# Access Compliance Report

## Public Rights-of-Way

### (Curb Ramps)

Intersection ID: 47361	Main Street: PARK_RD	Cross Street: N/A	Location: NE
ADA ID: EE93AC60676D	Ramp Type: Perp	Initial Pass/Fail: Fail	Overall Compliance: No
Codes/Mitigation Info/Possible Solution		Field Measurements/Component Compliance	
Severity Score: 12.5

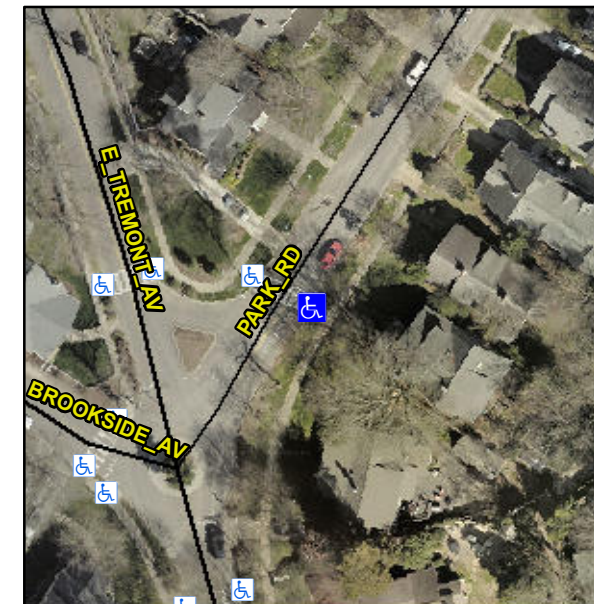
Compliance	Description	Data	Compliance	Description	Data
N/A	Ramp Length (in)	106.0	No	Ramp Slope (%)	8.9
Yes	Ramp Width (in)	67.0	Yes	Ramp XSlope (%)	1.5
N/A	Flare Type LT	N/A	N/A	Flare Type RT	N/A
N/A	Flare Slope LT (%)	N/A	N/A	Flare Slope RT (%)	N/A
N/A	Flare Traversable LT?	N/A	N/A	Flare Traversable RT?	N/A
N/A	Landing Length (in)	N/A	N/A	DWS Provided?	N/A
N/A	Landing Width (in)	N/A	N/A	DWS Contrast?	N/A
N/A	Landing Slope (%)	N/A	N/A	DWS Length (in)	N/A
N/A	Landing X Slope (%)	N/A	N/A	DWS Full Width?	N/A
N/A	Landing Curb? (Y/N)	N/A	N/A	DWS Offset (in)	N/A
N/A	Shared Landing?	N/A			
N/A	Gutter Ponding?	N/A	N/A	Gutter Slope (%)	N/A
N/A	Gutter Lip Ht (in)	2.0	N/A	Gutter X Slope (%)	N/A
N/A	Painted X Walk1?	Yes	N/A	Painted X Walk2?	N/A
	X Walk 1 Direction	To NW		X Walk 2 Direction	N/A
N/A	X Walk 1 Width (in)	108.0	N/A	X Walk 2 Width (in)	N/A
	X Walk 1 Slope (%)	2.8		X Walk 2 Slope (%)	N/A
	X Walk 1 X Slope (%)	2.0		X Walk 2 X Slope (%)	N/A

**Remove & Replace Entire Ramp.**

**R304.2.2**
